# Access Compliance Report

## Public Rights-of-Way

### (Curb Ramps)

Intersection ID: 42465	Main Street: CASTLE_WATCH_AV	Cross Street: KINGS CROWN_WY	Location:	N
ADA ID: 5B748376C0D4	Ramp Type: PerpDiag	Initial Pass/Fail: Fail	Overall Compliance: No	Severity Score: 61.25
Codes/Mitigation Info/Possible Solution		Field Measurements/Component Compliance

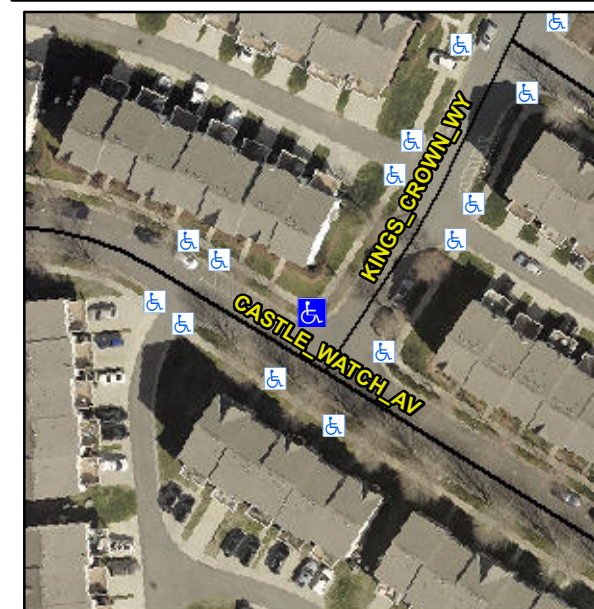
Compliance	Description	Data	Compliance	Description	Data
N/A	Ramp Length (in)	104.0	No	Ramp Slope (%)	12.5
No	Ramp Width (in)	25.0	No	Ramp XSlope (%)	2.4
N/A	Flare Type LT	N/A	N/A	Flare Type RT	N/A
N/A	Flare Slope LT (%)	N/A	N/A	Flare Slope RT (%)	N/A
N/A	Flare Traversable LT?	N/A	N/A	Flare Traversable RT?	N/A
N/A	Landing Length (in)	N/A	N/A	DWS Provided?	N/A
N/A	Landing Width (in)	N/A	N/A	DWS Contrast?	N/A
N/A	Landing Slope (%)	N/A	N/A	DWS Length (in)	N/A
N/A	Landing X Slope (%)	N/A	N/A	DWS Full Width?	N/A
N/A	Landing Curb? (Y/N)	N/A	N/A	DWS Offset (in)	N/A
N/A	Shared Landing?	N/A			
N/A	Gutter Ponding?	N/A	N/A	Gutter Slope (%)	N/A
N/A	Gutter Lip Ht (in)	N/A	N/A	Gutter X Slope (%)	N/A
N/A	Painted X Walk1?	No	N/A	Painted X Walk2?	No
	X Walk 1 Direction	To SW		X Walk 2 Direction	To SE
N/A	X Walk 1 Width (in)	N/A	N/A	X Walk 2 Width (in)	N/A
	X Walk 1 Slope (%)	1.7		X Walk 2 Slope (%)	2.6
	X Walk 1 X Slope (%)	1.4		X Walk 2 X Slope (%)	2.0

N/A	Ramp inside XWalk1?	N/A	N/A	Ramp inside XWalk2?	N/A
	Road Slope (%)	2.2	N/A	Clear Space?	N/A
	Road X Slope (%)	0.7	N/A	Clear Space to XWalk (in)	N/A
N/A	Any Obstructions?	N/A	N/A	Storm Grate/Utility Hazard?	N/A
	Obstruction Type			Storm Grate/Utility Type	
		N/A			N/A
			Yes	Surface Condition? (G/P)	Good

**Remove & Replace Curb Ramp With Two New Directional Ramps or Equivalent.**
